# LAREDO COLLEGE VETERANS SERVICES CENTER ADDENDUM No. 2

DATED: December 05, 2024

- **PROJECT:** Veterans services center Sheridan Rd, Laredo, TX 78040
- ARCHITECT: Cavazos Architects 9114 McPherson Rd. #2501 Laredo, Texas 78045 956/724-8123

## ADDENDUM #2

#### ITEM #1: Revised Civil Sheets

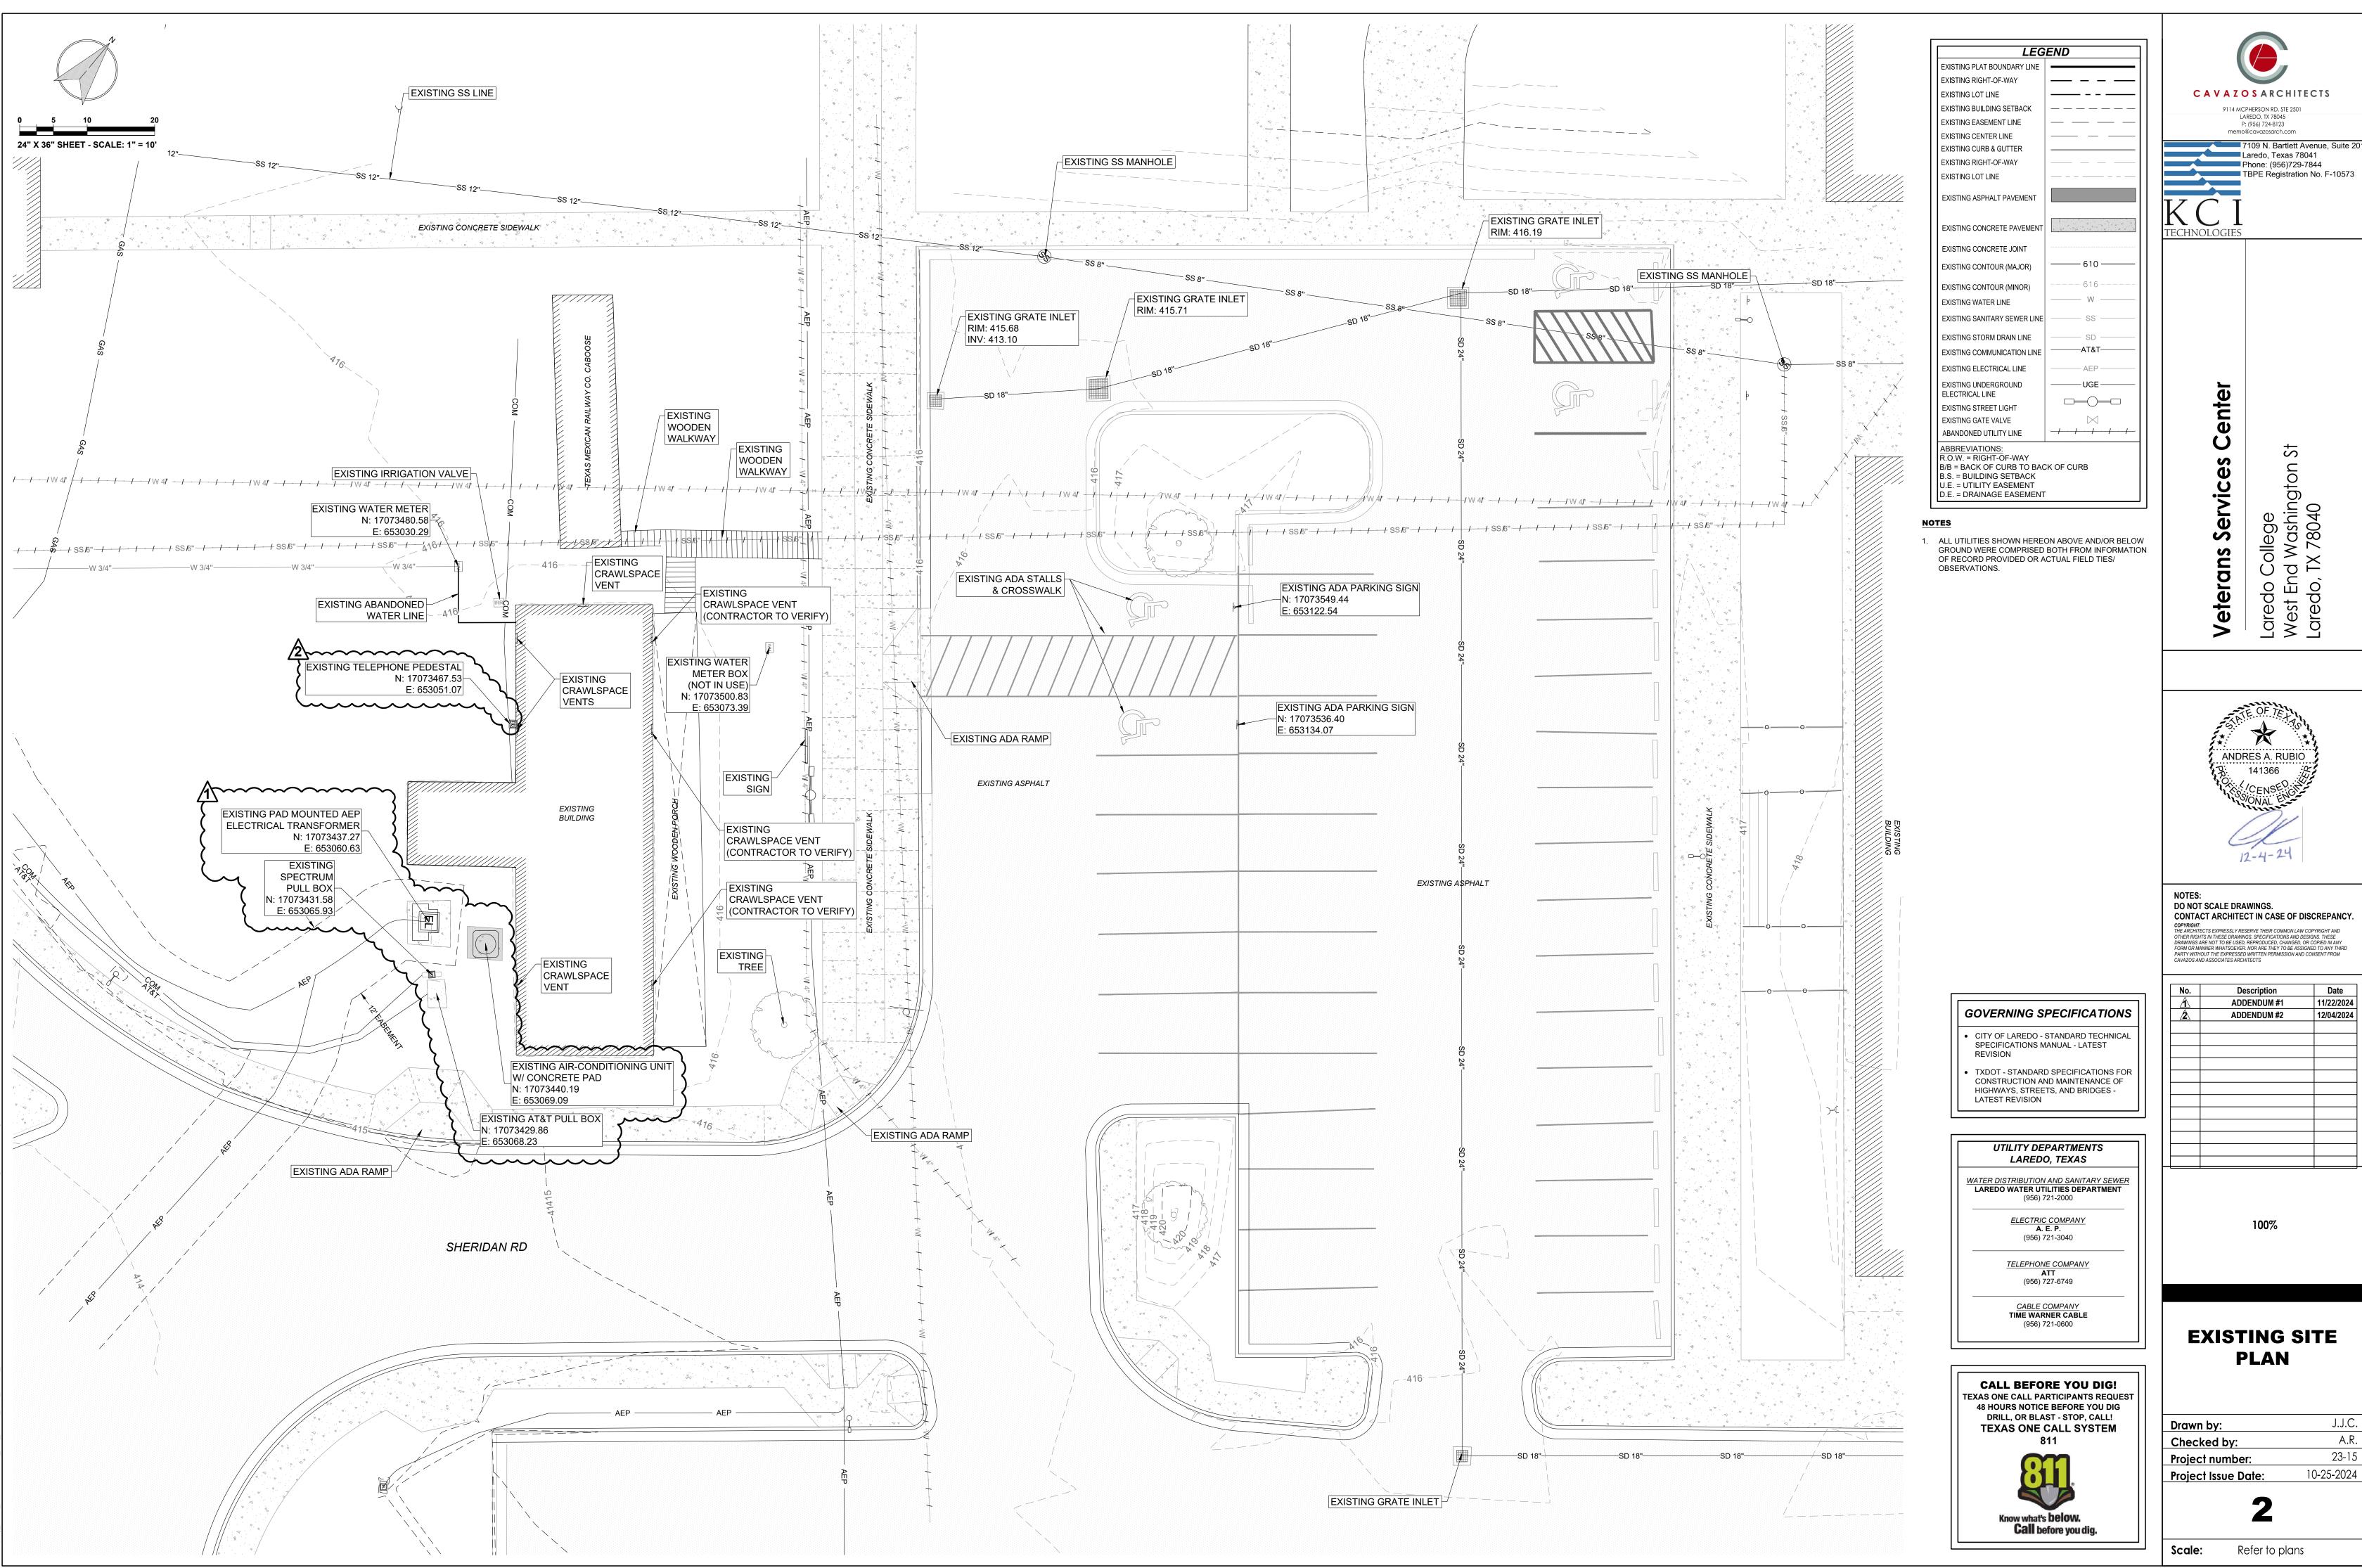
- Sheet C2 Updated existing communications pedestal note.
- Sheet C3 Updated existing communications pedestal note.

#### ITEM #2: Revised Electrical Sheets

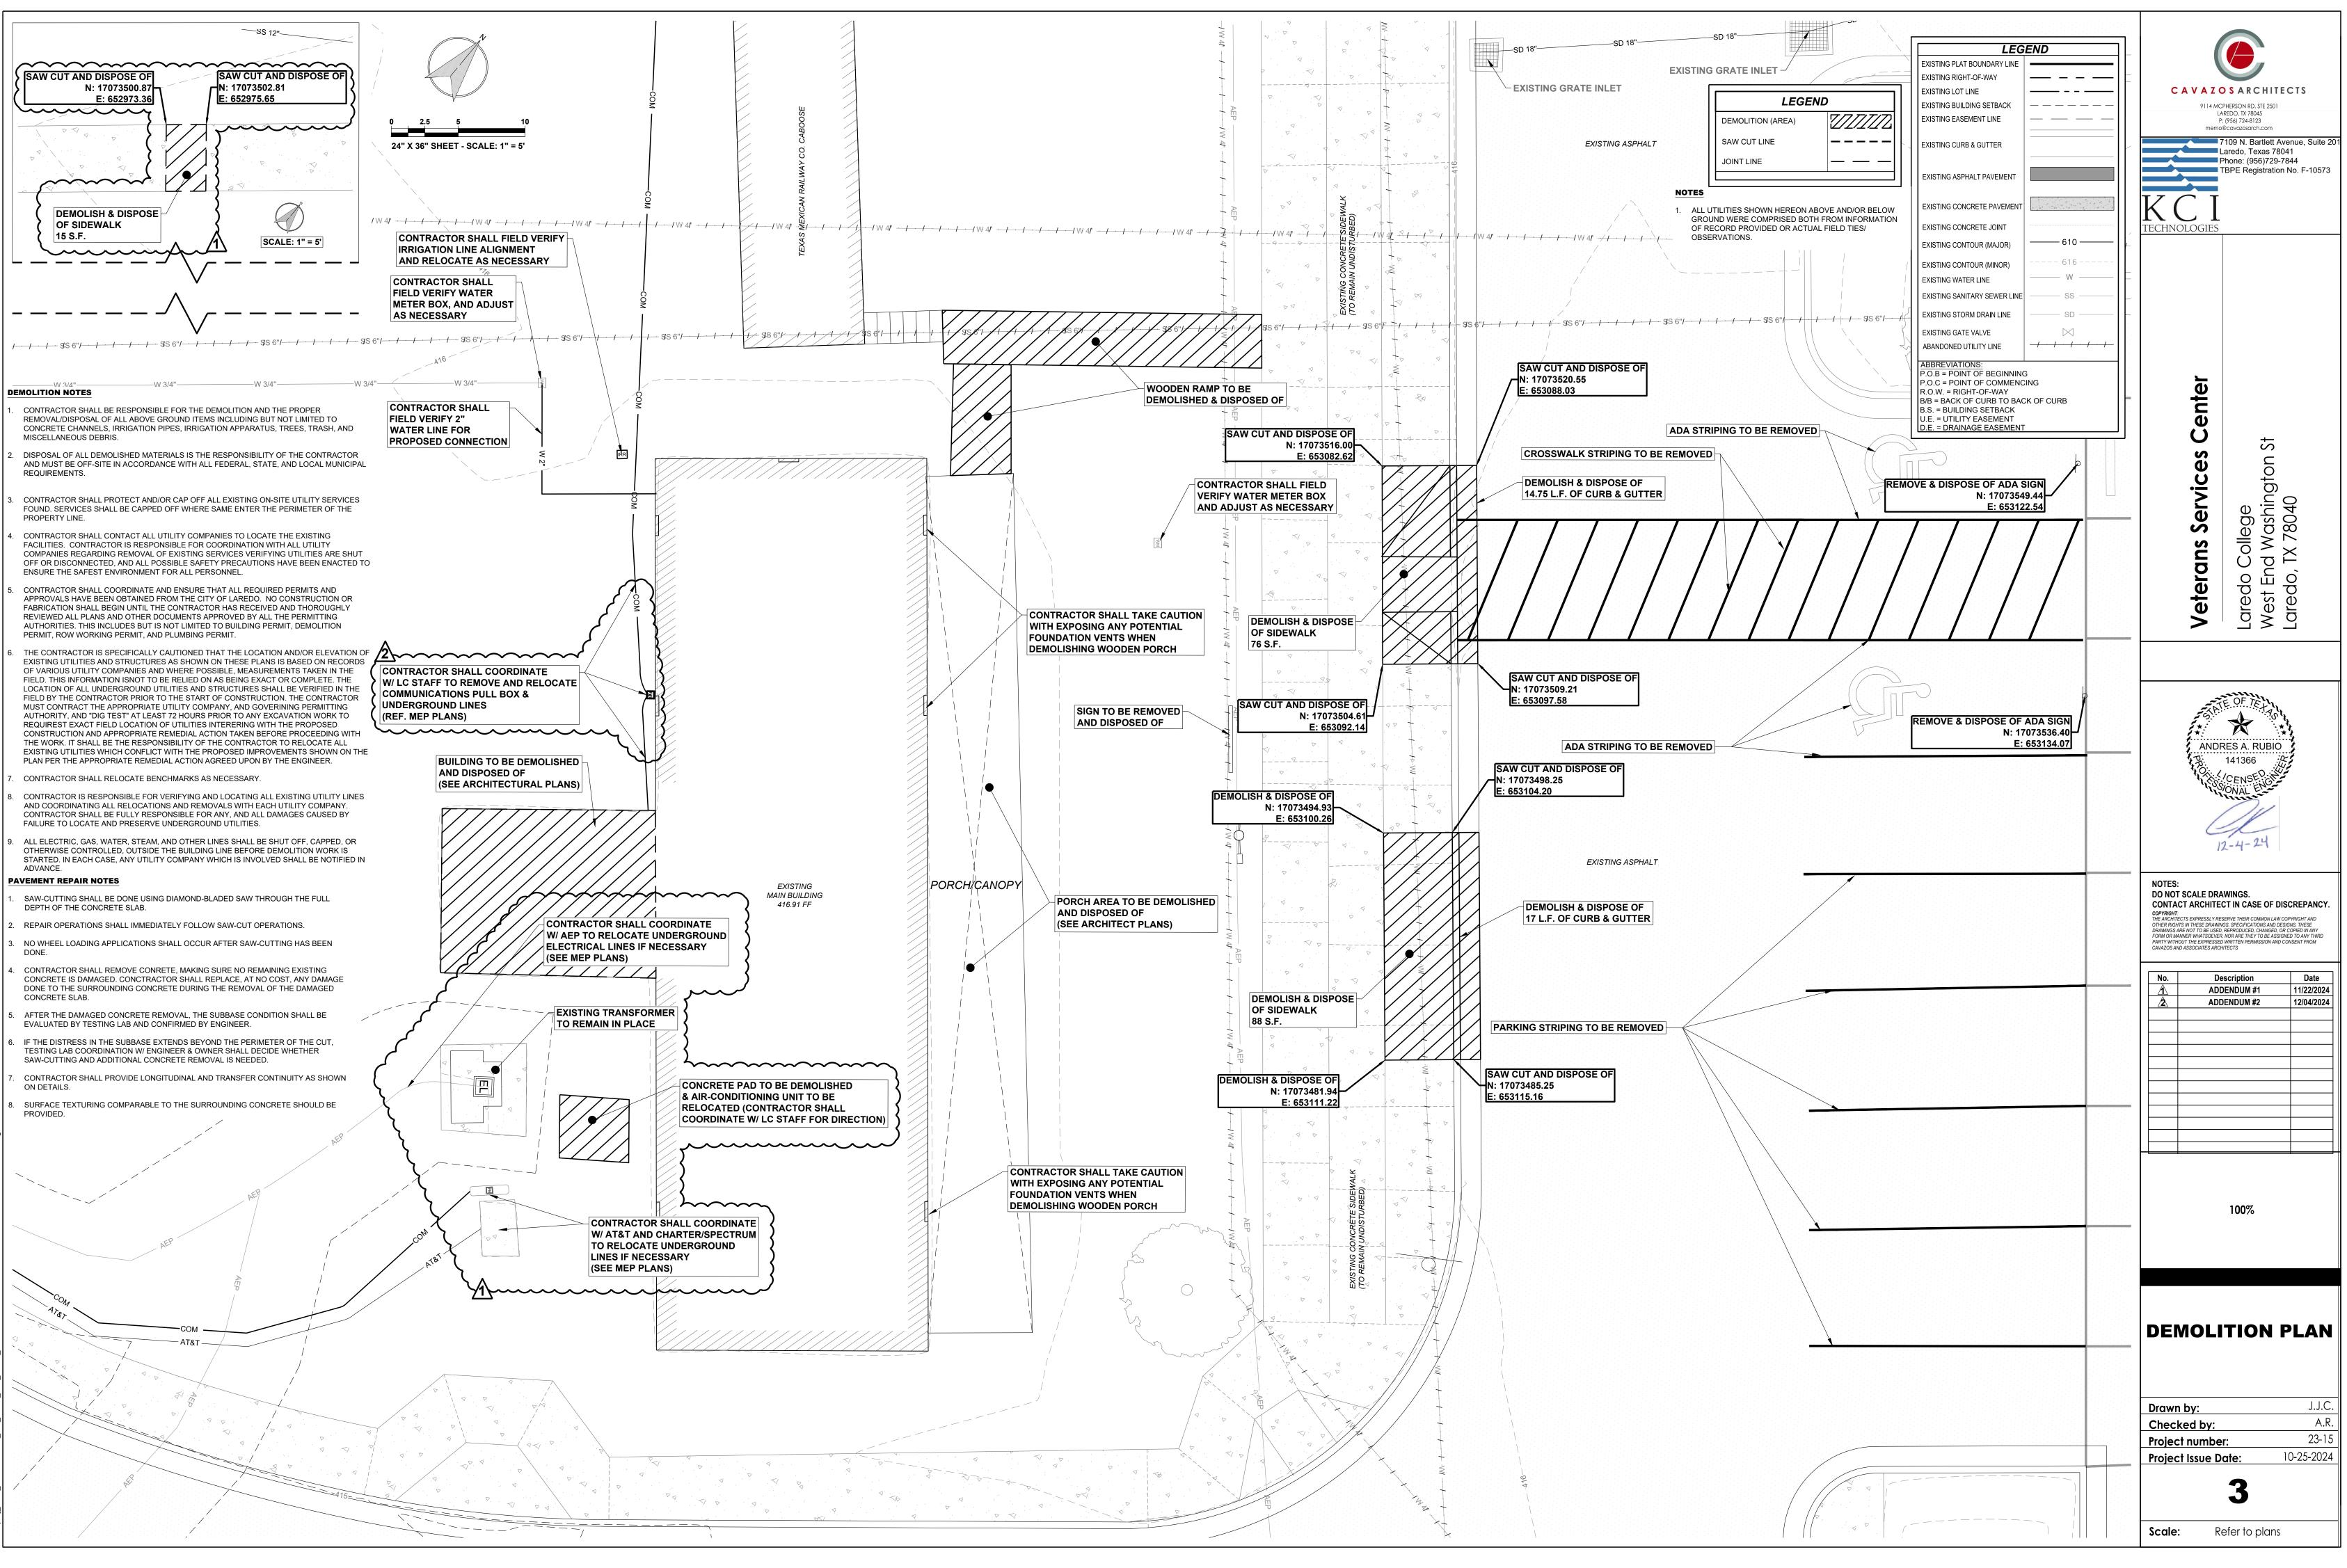
- Sheet EDP-101 Existing telephone pedestal to be relocated by contractor.
- Sheet ES-101 Existing telephone pedestal proposed new location with new conduit to MDF room.
